Title - Sujet Walk In Cooler	
Solicitation No. - N° de l'invitation 21401-131879/A	Amendment No. - N° modif. 002
Client Reference No. - N° de référence du client 21401-13-1879	Date 2013-01-30
GETS Reference No. - N° de référence de SEAG PW-\$KIN-650-6049	
File No. - N° de dossier KIN-2-38261 (650)	CCC No./N° CCC - FMS No./N° VME
Solicitation Closes - L'invitation prend fin at - à 02:00 PM on - le 2013-02-25	
Time Zone Fuseau horaire Eastern Standard Time EST	
F.O.B. - F.A.B. Specified Herein - Précisé dans les présentes Plant-Usine: <input type="checkbox"/> Destination: <input type="checkbox"/> Other-Autre: <input checked="" type="checkbox"/>	
Address Enquiries to: - Adresser toutes questions à: Rombough, Lori	Buyer Id - Id de l'acheteur kin650
Telephone No. - N° de téléphone (613) 545-8061 ()	FAX No. - N° de FAX (613) 545-8067
Destination - of Goods, Services, and Construction: Destination - des biens, services et construction:

AMENDMENT #002

The intent of this amendment is to answer questions from potential bidders.

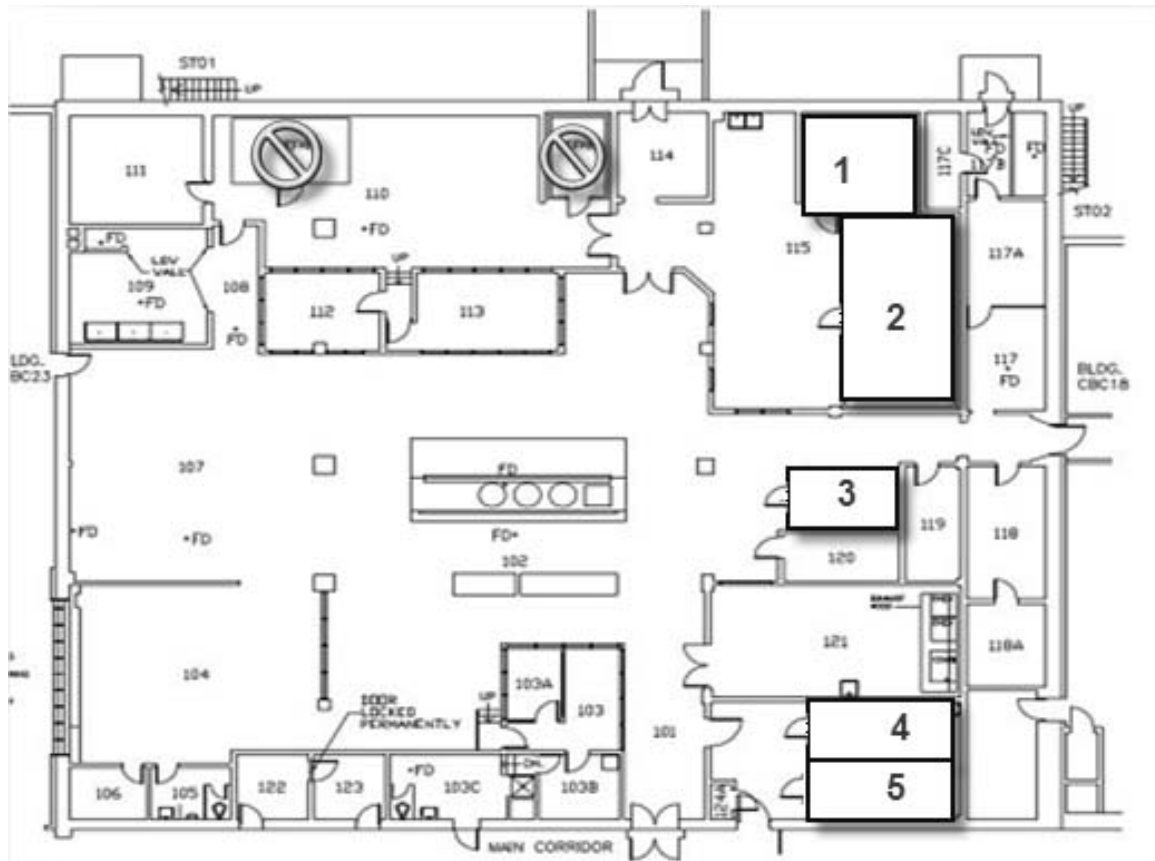
Q3. Page 6 item 2.1. The walk-ins are numbered from 1-5 but on the floor plan they are numbered from 3-7 can I get clarification.

A3. An additional image depicting walk-ins #1 to 5 is provided in this amendment.
